**NUMBER:** 25-003-20

Evaporative Emission Control System (EVAP) Purge Line Kinked

This bulletin involves inspecting and possibly replacing the EVAP purge valve assembly.

Fig. 2  
Purge Line Routing

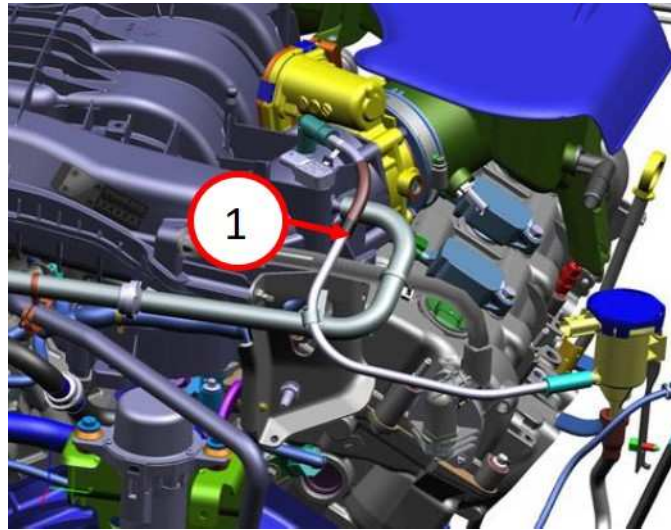
2. Install the new purge valve assembly. Re-route purge line behind brake boost tube (Fig. 2) .

**NOTE: Remove the original clip that held the purge line to the brake booster line and discard.**

Fig. 3  
Correct EVAP Purge Line Elbow

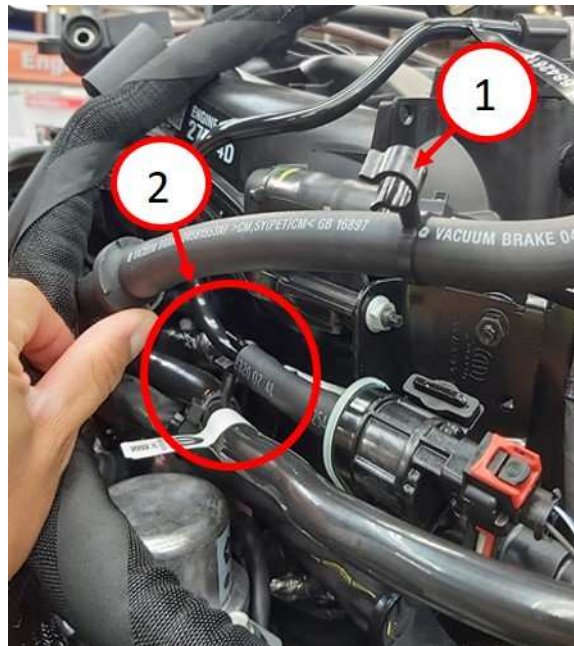
3. Remove clip from brake boost tube (Fig. 3) .
